SUNDRY NOTICES AND REPORTS ON WELLS

8. Well Name and No.
DOROTHY FEDERAL #29. API Well No.
30-025-3571710. Field and Pool or Exploratory Area
N/A11. County or Parish, State
LEA, NEW MEXICO

Dorothy Fed 2

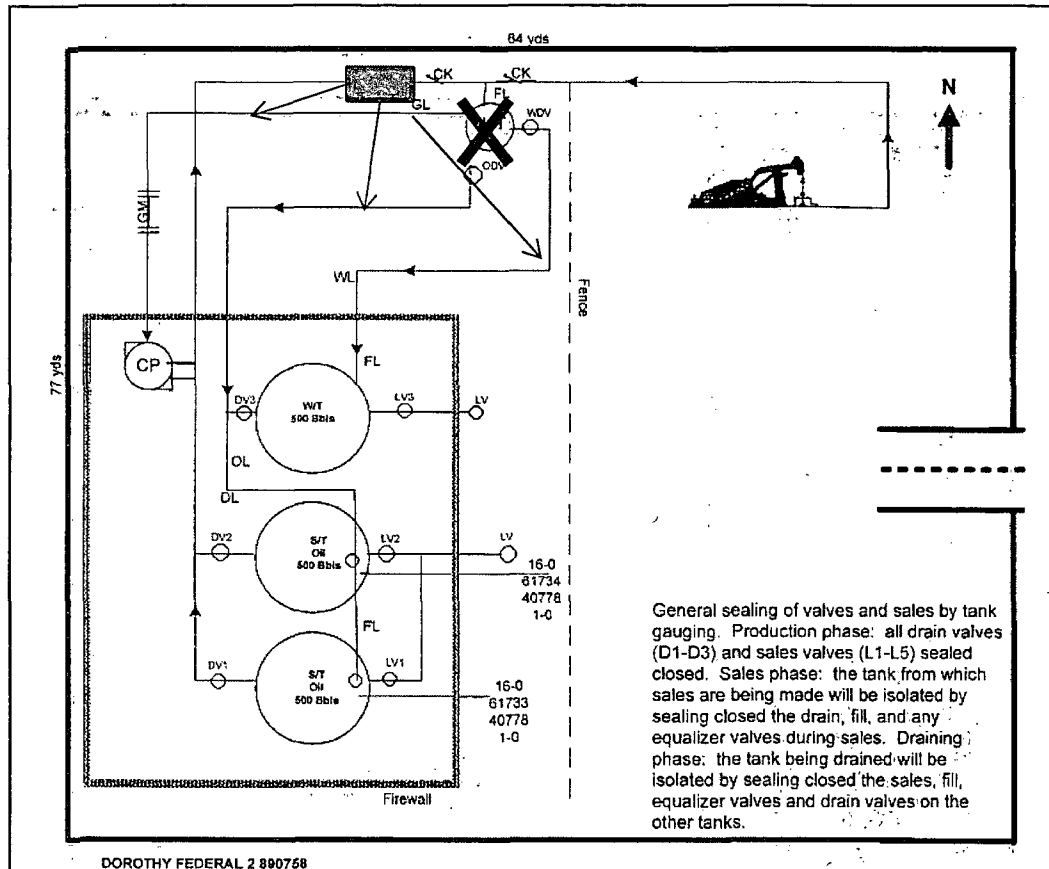
Due to high line pressure, Chevron intends to add temporary 3 phase separator (denoted by blue square) to bypass the HT (denoted by the big X as bypassed). Once the line pressure is back to normal, we will remove the temporary separator and use existing facility like before. Expected duration of temporary solution is six (6) months.

Due to High line pressure, we will add temporary 3 phase separator (denoted by blue square) to bypass the HT (denoted by the big X as bypassed). Once the line pressure is back to normal, we will remove the temporary separator and use existing facility. Like before. Expected duration of temporary solution is 6 months
